FirstEnergy Nuclear Operating Company

Beaver Valley Power Station, Unit No. 2  
Docket No. 50-412, License No. NPF-73  
Additional Technical Information Pertaining to License Amendment Request No. 08-027  
(TAC No. ME1079)

Requested Additional Technical Information

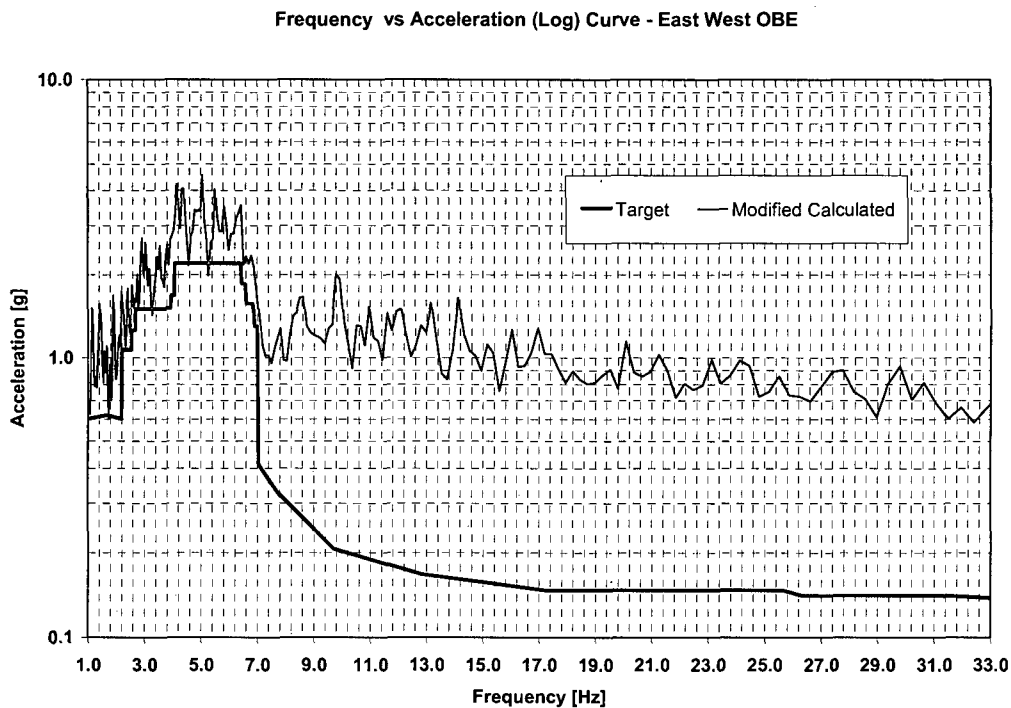
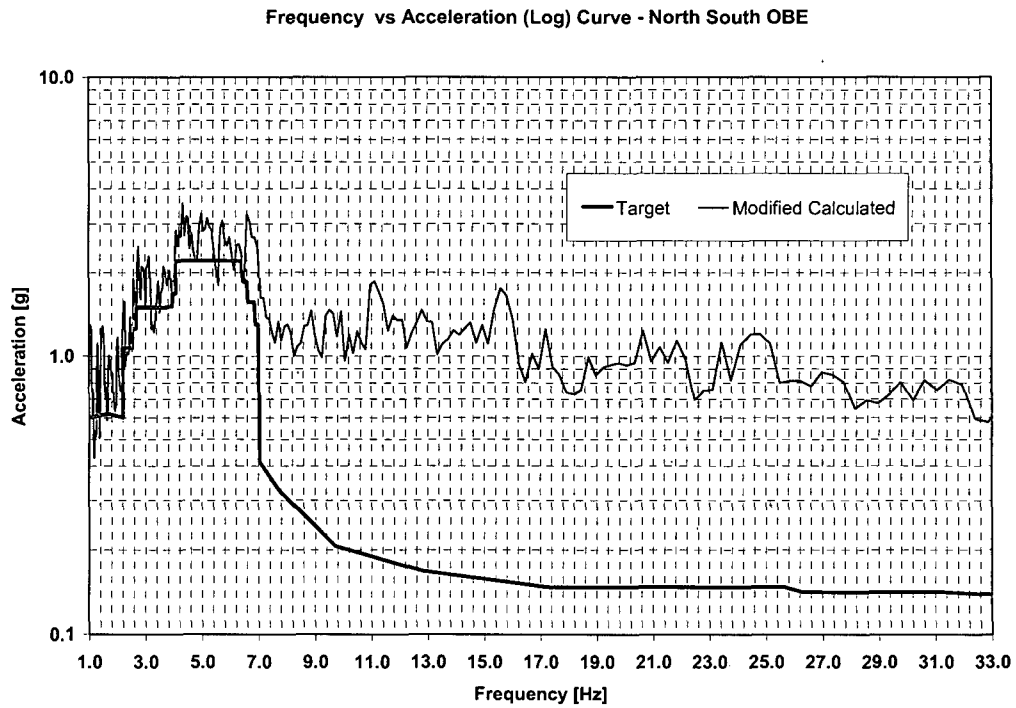
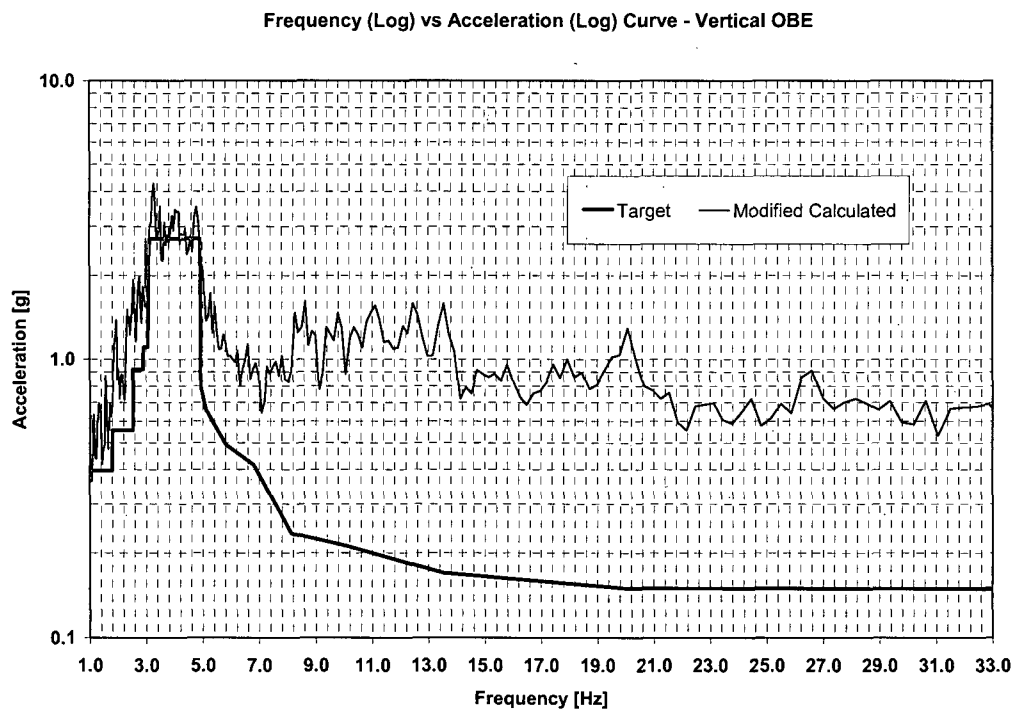
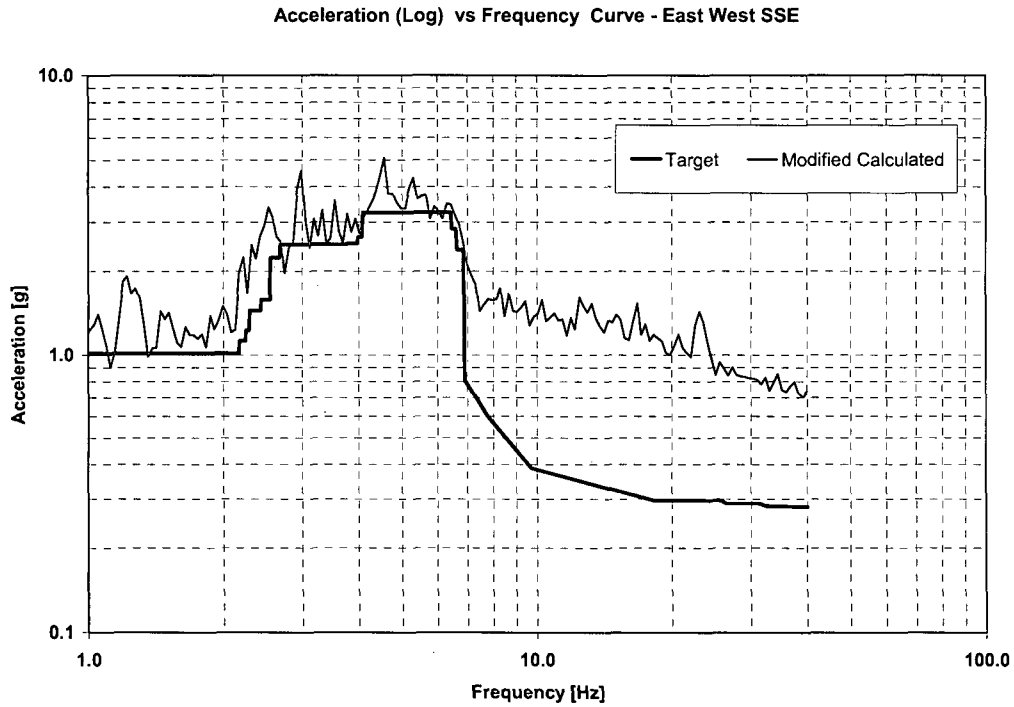
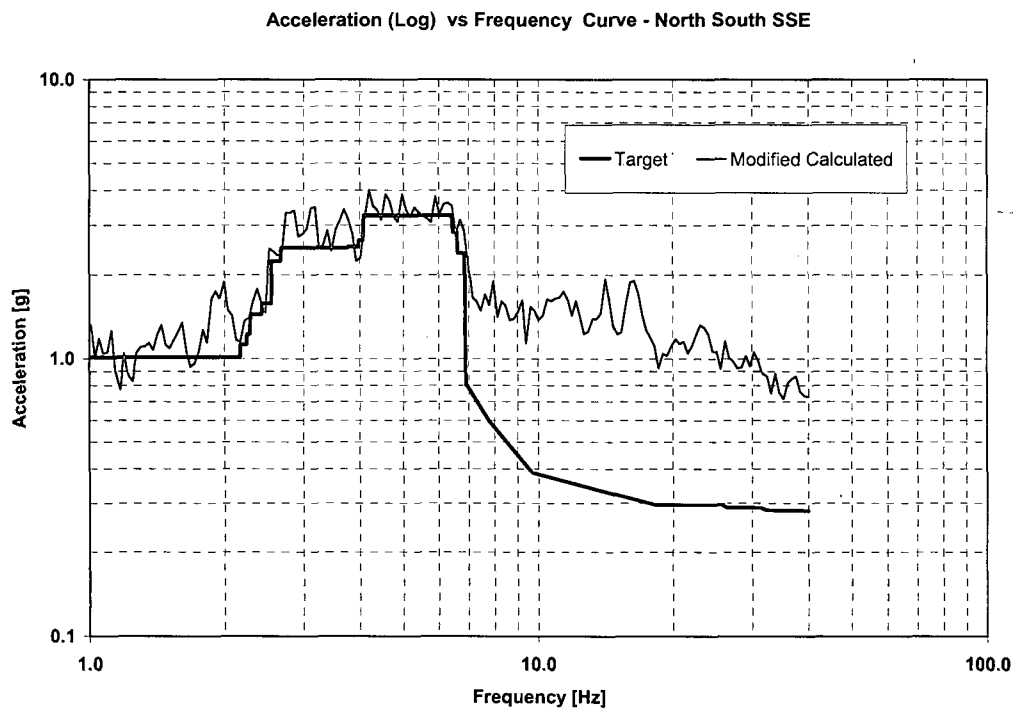
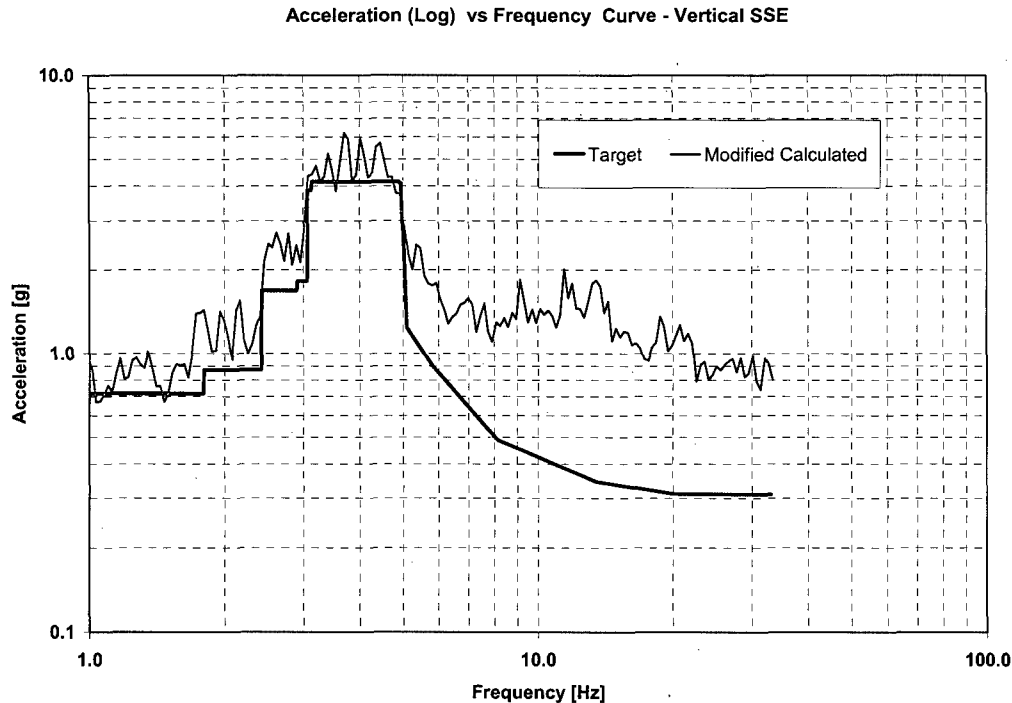
**iv. A comparison of the artificial response spectra and the target response spectra.**

Typical comparison plots of the artificial response spectra versus the target response spectra are provided in Figures 1 through 6. One set of response spectrum is provided for Operating Basis Earthquake and one set is provided for Safe Shutdown Earthquake. The attached plots are extracted from Reference 17.

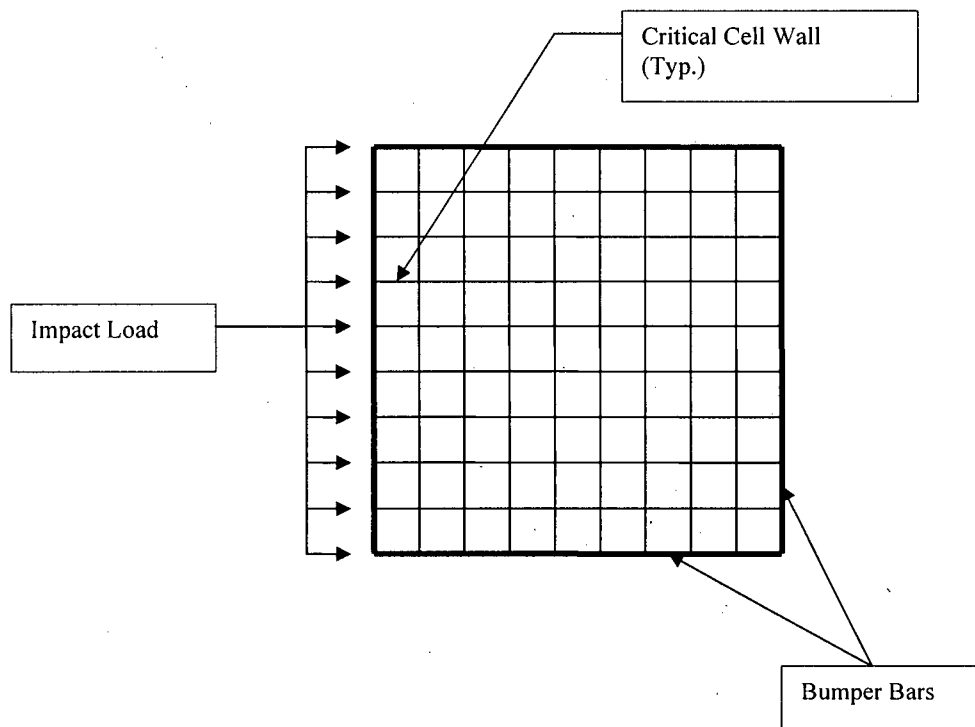
- 5. For Section 5.5.3 of Enclosure A of the application demonstrate that the rack modules meet the provisions of NF-3322.2(d) for width ratios.**

NF-3322.2 of the ASME Code considers the effect of slenderness ratio for single boxes, and it is not clear whether this section of the Code applies to the honeycombed structure design of the fuel storage racks. Nevertheless, the provisions of NF-3322.2 for width ratios have been included in the structural evaluation of the BVPS Unit No. 2 spent fuel racks.

Since the slenderness ratio of a single fuel storage cell within the honeycomb array exceeds the limit imposed by NF-3322.2, the stress results from DYNARACK have been manually adjusted to incorporate the slenderness ratio effects. This is accomplished by calculating the effective section properties (area and moment of inertia) of the rack cellular structure using the methodology in NF-3322.2 for a single rectangular beam. Next, the stress adjustment factors are calculated as the ratio of the effective section properties to the gross section properties. Finally, the maximum stress factors from DYNARACK are divided by the limiting adjustment factor to account for the slenderness ratio effect. The details of the calculation are documented in Reference 18.

**Figure 7 – Finite Element Model of Cask Pit Platform**

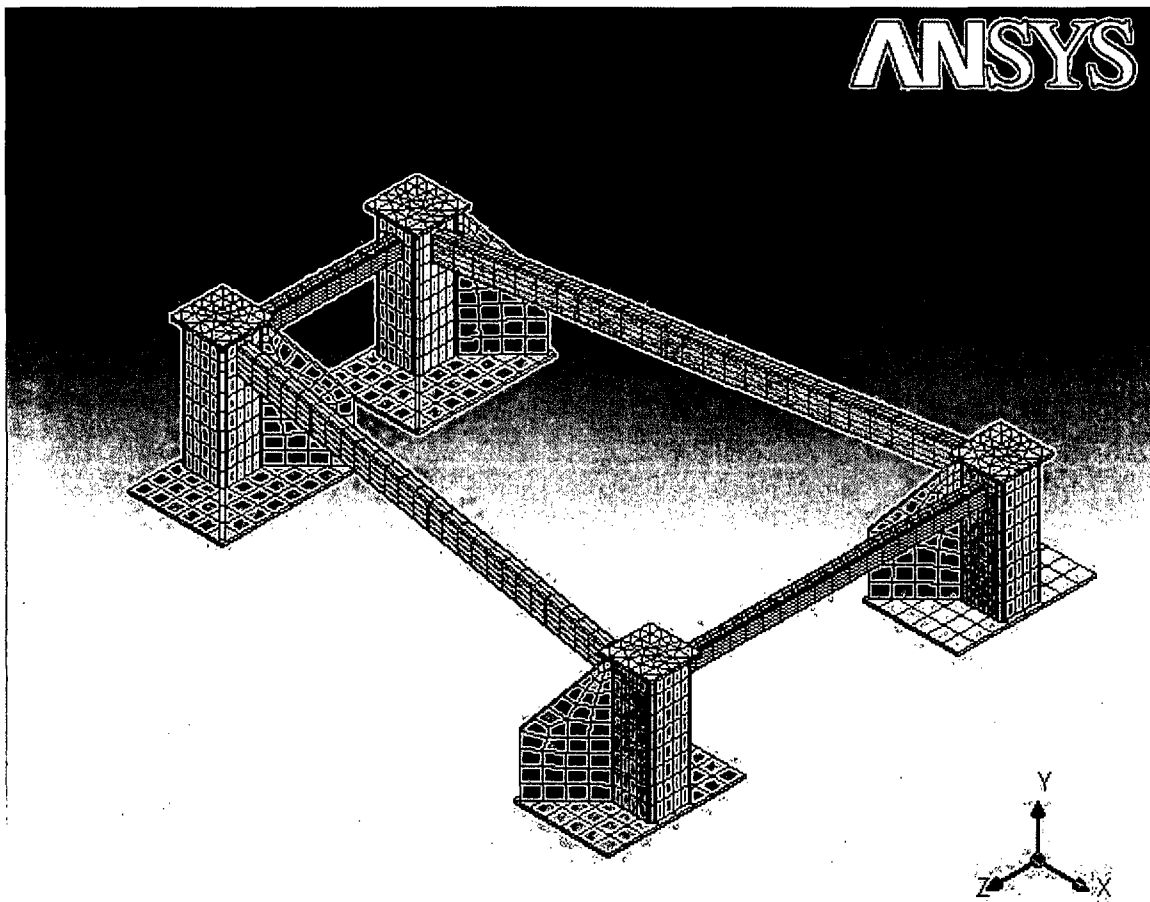
**7. Provide sufficient numerical information to support the stated factors of safety in Sections 5.7 through 5.9 of Enclosure A of the application.**

The cask pit platform analysis is carried out in two steps. First a single rack dynamic analysis is performed using DYNARACK in order to extract the maximum loads at the rack-platform interface. Then, after all loads are obtained, the Solidworks Computer-aided design (CAD) model of the cask pit platform is imported into ANSYS Workbench, meshed, and subject to the maximum loads. Solidworks is a commercially available CAD program, which has been validated under Holtec's 10 CFR Part 50 Appendix B QA Program (Reference 25). Holtec has also performed a QA validation of ANSYS (Reference 26), which is a commercial finite element program. Based on the finite element analysis (FEA) results, the stresses and safety factors are evaluated. The finite element model of the cask pit platform is shown below in Figure 7.

The maximum loads applied at each pedestal support location are summarized in the tables below. The loads were produced from the single rack dynamic analysis.

The calculated stresses in the cask pit platform as determined by ANSYS are compared with the stress limits per ASME Subsection NF for linear type supports. The following table summarizes the minimum safety factor for various platform components under normal (Level A) and faulted (Level D) conditions. The analysis is documented in Reference 19
